Wisconsin Department of Transportation

Proposal #12: 6217-00-78
Town of Columbus, Old STH 73 Rd
Crawfish River Bridge, B-11-0175
Local Street
Columbia County

This is Addendum No. 01, which provides for the following:

ADDENDUM NO. 01

QUANTITIES, TYPICAL SECTION & NOTES

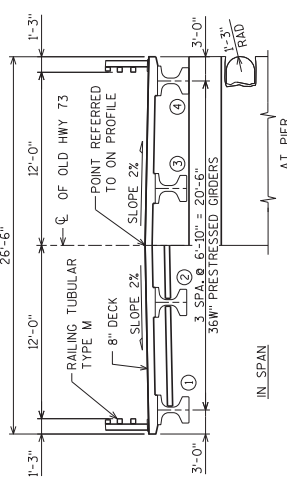
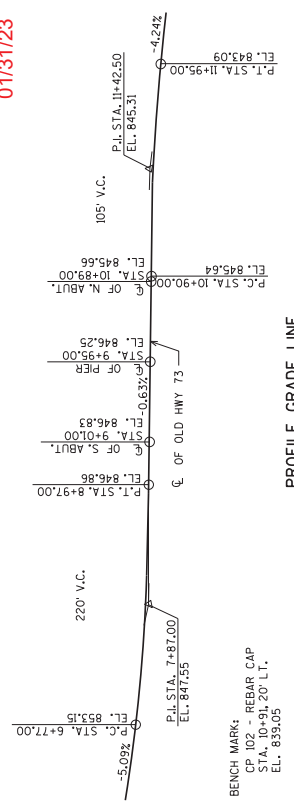
| Revised Plan Sheets | |
|---------------------|--|
| 40 | Quantities (switched N. Abutment and Pier quantities) |
